**Wheaton High School and Thomas Edison High School of Technology, Mandatory Referral, 2013011**

**Completed: 12/5/12**

This report consists of the proposed Mandatory Referral for the Wheaton High School and Thomas Edison High School of Technology Modernization, submitted by MCPS pursuant to Section 7-112 of the Regional District Act. The related Forest Conservation Plan review is in a separate memo to the Planning Board. The Planning Board action on the Mandatory Referral is advisory, but the Board decision on the related Forest Conservation Plan is regulatory and binding.

**SUBJECT:** Wheaton / Edison High School Mandatory Referral

Figure 4: Proposed Development

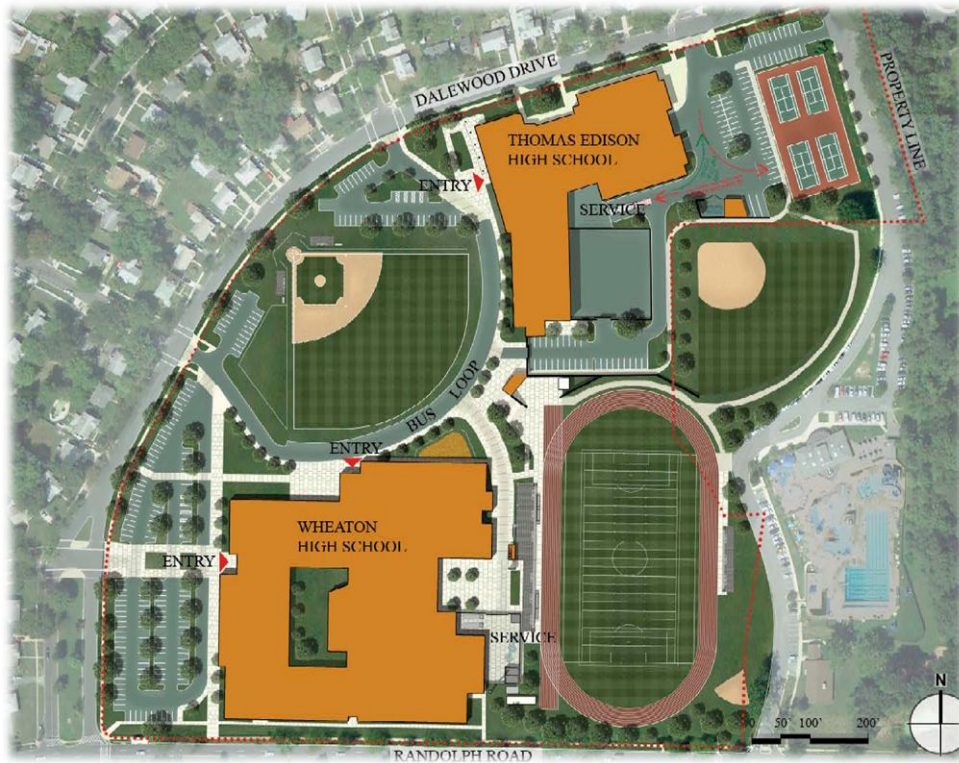
The above Development Standards table shows that the proposed project does not meet the zone's building height and front parking facility setback requirements. However, staff believes that these violations are not significant enough to recommend denial for the following reasons:

- The proposed front parking setback of six feet is well under the zone's minimum requirement of 25 feet. Staff feels that the impact of the reduced setback is mitigated by landscaping along the Dalewood Drive right-of-way (ROW), which is in accordance with the landscaping requirements in Section 59-E of the Zoning Ordinance. The impact of the reduced setback is also mitigated by the fact that the parking frontage is broken up into small sections along the entire site frontage on Dalewood Drive.

- The proposed buildings are over the 35-foot height limit of the R-60 Zone. However, the design of the buildings reduces the impact of their additional height by placing the greatest height in the center of the top floor of each building.

The closeness of the front parking facility is mitigated by the landscaping that borders the site. The plantings along this edge of the property will provide a soft edge that would be compatible with the residential uses directly across the street. Furthermore, Staff notes that significant efforts have been made to provide parking on-site. The baseball field will be relocated to an area along Dalewood Drive between the two proposed school buildings, where its edges will effectively be utilized to maximize the bus loop area and provide additional parking spaces between the new buildings.

Figure 3 – Proposed Conditions of Approval

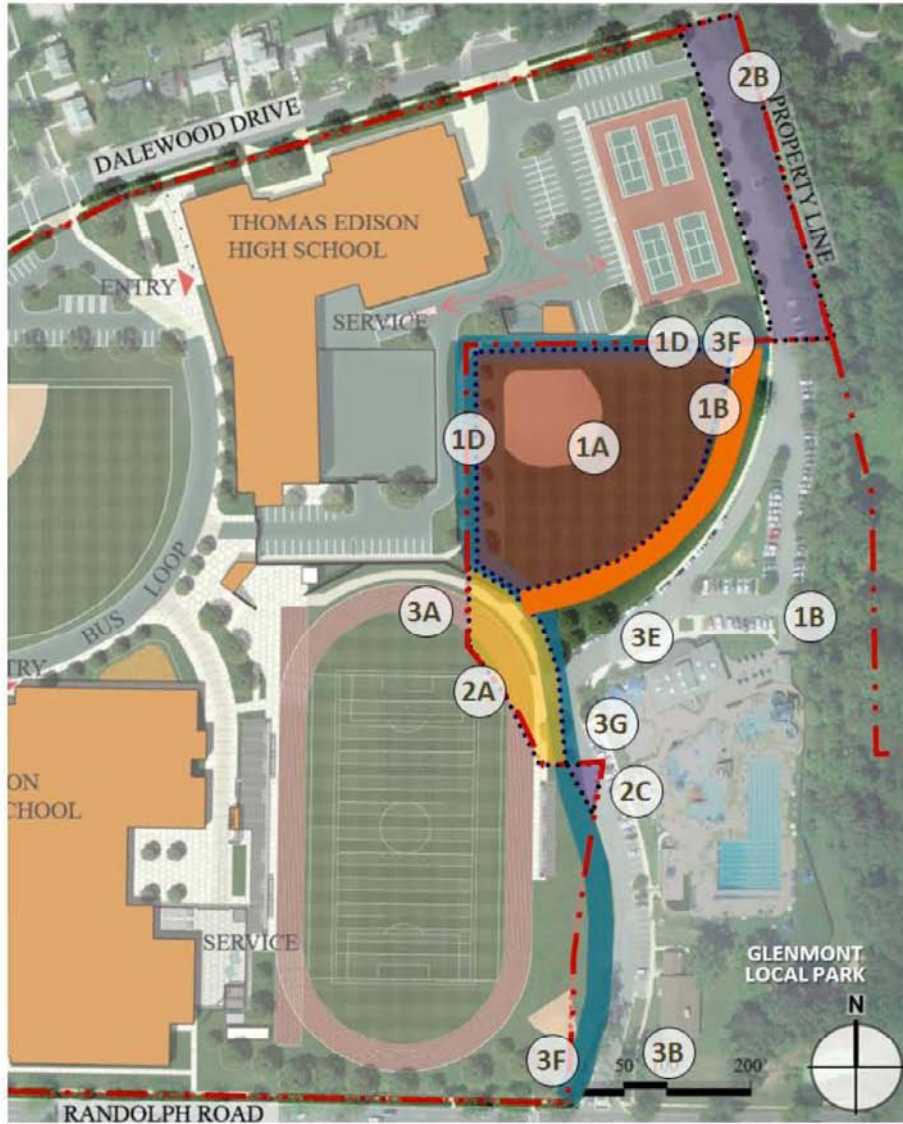
- A. MCPS may take the Park softball field out of public use for staging or accessing its construction area(s) for a period of up to five (5) years upon procuring the appropriate Park Construction Permit. When the renovations are completed, MCPS to reconstruct the field to meet Park standards. These renovations should ensure that the field meets ADA standards and that maintenance access to the field is provided from the Park. Park softball field construction specifications and standards will be provided to MCPS. ADA parking for the field is proposed to be on MCPS, therefore, MCPS will be responsible for maintaining exterior access route to the field.

- B. Required stormwater management (SWM) facilities for the reconstructed field to be included in the field renovation. Treatment concept, design/layout, and construction details of these facilities to be determined as part of the Technical Review for Park Construction Permit in coordination with, and be acceptable to, M-NCPPC Montgomery Parks' staff.

- A. M-NCPPC to convey, in fee simple, to Montgomery County Public Schools, approximately 11,600 square feet of parkland, part of which is within the current softball field, to accommodate the reconfigured school stadium field (*Figure 3*).
- B. MCPS to convey to M-NCPPC, in fee simple, the existing portion of the park entrance driveway and parking on County land between Dalewood Drive and current parkland to the south, consisting of approximately 28,650 square feet (*Figure 3*).
- C. MCPS to convey to M-NCPPC Montgomery Parks, in fee simple, approximately 735 square feet triangle of County land that currently contains a portion of drive aisle and parking for Glenmont Local Park (*Figure 3*).

- E. Add concrete curbing along the parking area on M-NCPPC parkland between Randolph Road and the softball field.
- F. Provide landscaping buffer along western edge of Park along redeveloped stadium field and softball field.

- 2B and 2C: proposed land convey to Parks
- 2A: proposed land convey to MCPS
- 1A: Construction Staging Area
- 3F: Landscaping Buffer
- 1B: Stormwater Management for Softball Field
- Existing Property Lines
